Pitt Town Draft design guidelines

AREAS OF CHANGE TO THE HAWKESBURY D.C.P PART D - SPECIFIC DEVELOPMENT.
(examples based on lots 750sqm)

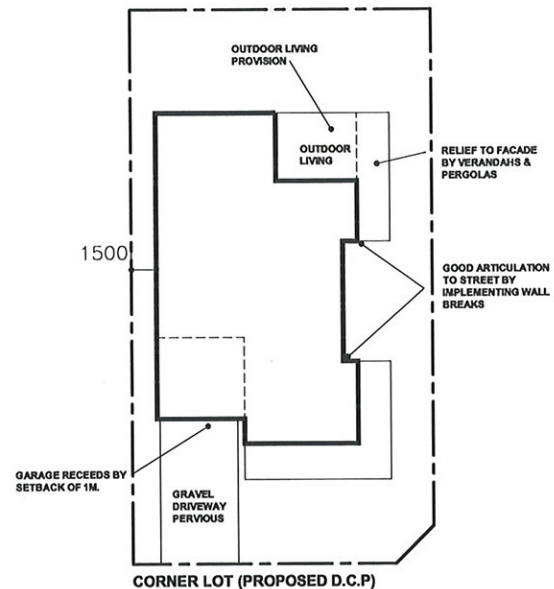
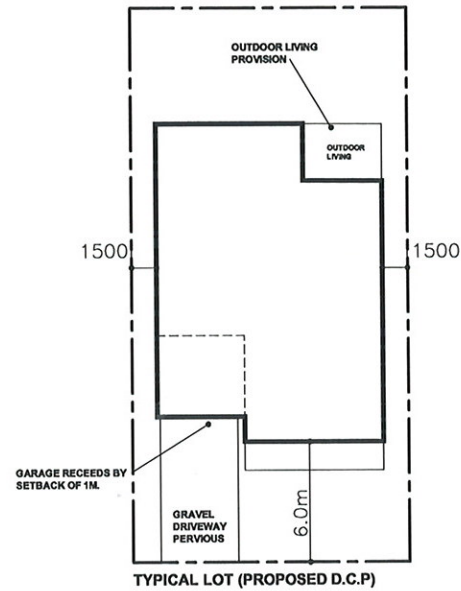
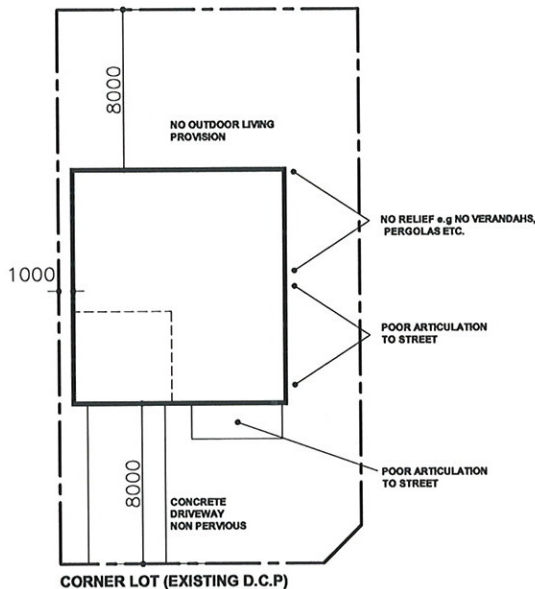
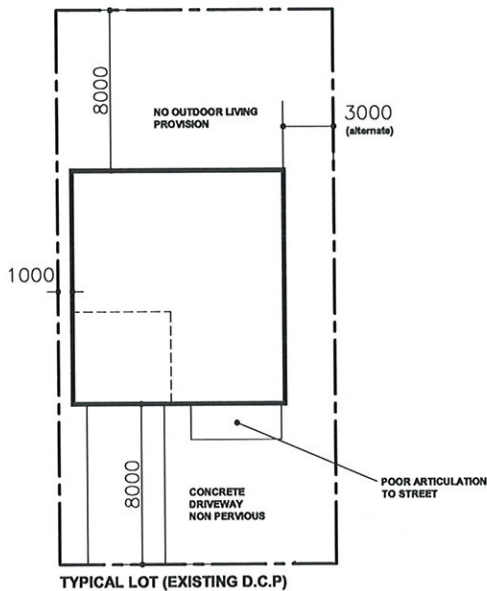
items	existing	proposed	reference	justification reference no.
site coverage	45% (750m ²)	lots < or =750m ² 60%	PART E 4.14.2 Rules	1
front setback	8m (750m ²)	6.0m (lots<999m ²) 8.0m (lots>1000m ²)	PART E 4.14.2 Rules	2
side setback	3m (750m ²)	1.5m (single) 1.5m (double)	PART E 4.14.2 Rules	3
rear setback	8m (750m ²)	4m (lots<750m ²) 6m (lots>750m ²)	PART E 4.14.2 Rules	4
garage setback (from house)	2m	1m	PART E 4.14.2 Rules (b)	5
corner lot articulation	n/a	1 step min. @400mm	n/a	6
main roof pitch	n/a	24°	n/a	7
eave	600mm	450mm	n/a	8
outdoor living	n/a	3m x 3m	n/a	9
driveway material	sealed	granular material /no concrete	PART D 1.9 Car Parking	10
building height envelope	1.8m height and 45° from boundary	remove	PART D 1.3 Height	11

- 1 a maximum site coverage of 60% is required on lots up to 750sqm in order to accomodate a good mix of single storey and two storey floor plans catering for different market segments.

- 2 a minimum front setback is required for lots under 999m², to maximise the private open space potential and provide a reasonable open area for large mature trees. a greater setback will also effect the length of driveway, thus increasing the percentage of impermeable surface calculation.

- 3 a minimum side setback of 1.5m is required to allow for construction of single level homes on lots under 750m², and creating the opportunity for greater design flexibility on smaller lots.

- 4 a minimum rear setback of 4m is required to allow for construction of single level homes on lots under 750m². A 4m rear setback will also provide opportunity for lots with north facing side yards to accomodate courtyard design principles, encouraging cross flow ventilation and encouraging correct orientation.

- 5 a minimum garage setback of 1m is required to allow for greater rear open space on lots under 750m², whilst reducing the length of driveway, thus impacting on impermeability.

- 6 a minimum step of 400mm to an external wall to a corner facade will help provide interesting aesthetics from the street, and give visual relief by providing wall breaks, and encourage roof articulation. Wall articulation will also provide landscaping opportunities, providing greater relief by vegetation.

- 7 a minimum roof pitch of 24° is required to give the estate better proportioned streetscapes. This is particular on two storey dwellings where the roof pitch is visually impaired due to the view from ground level. By increasing the pitch to 24° the roof will be become balanced with the vertical proportions of a typical two storey home.

- 8 a minimum eave of 450mm is required to provide adequate shading to windows without the cost impact of modifying standard building trusses to a 600mm overhang, making building on the estate more affordable. 450mm with fascia and gutter equates to a 600mm horizontal overhang from the edge of a brick veneer dwelling.

- 9 a minimum outdoor living area of 3m x 3m is required to encourage the use of outdoor living within the estate. Better aesthetics are achieved by integrating an outdoor living space and using the same materials as the dwelling. Many home buyers add a temporary outdoor type structure (i.e aluminium/post and fibreglass roofing) after construction, which has poor aesthetics and does not reflect the same architectural language of the dwelling.

- 10 granular material or the dissapproval of concrete driveways are a requirement to reduce the impact of hard surface areas to the site. With the rural qualities of Pitt Town granular material is a favoured aesthetic over poor imitation paving, such as stencilled concrete patterns which are busy in pattern, and are not in keeping with the rural and historic qualities of the area.

- 11 the removal of the building height envelope is required due to the construction of two storey dwellings on lots smaller than 750sqm. The envelope will also impact on the construction affordability of housing if inset first floor construction is to take place. By constructing first floor walls directly onto ground floor walls, the building form will compliment the existing historic architectural language.
